TECHNICAL BULLETIN

TB No. AA-01163

Flitestep® Kits:

P/N 412-300-150 and 412-300-300

FIGURE 1

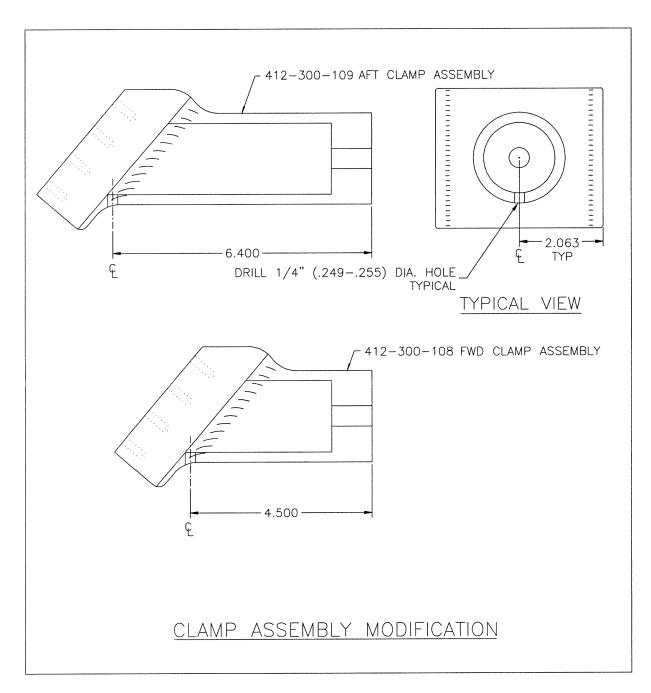
This technical bulletin is being issued in response to an incidence of water being retained inside of the Clamp Assemblies mounted to the helicopter's forward and aft crosstubes, used to support the Flitestep®. This trapped water is suspected in causing corrosion of the internal fastener which retains the Yoke portion of the Clamps. This

document details the procedure to add a drain hole to the upper Clamp Assembly to allow trapped water to

- 4. Drill a 1/4" (.249"- .255" diameter) drain hole, horizontal with the ground, at the lowest point of the internal space which is retaining water as shown in Figure 1. Deburr both sides of the hole after the drilling process is complete.
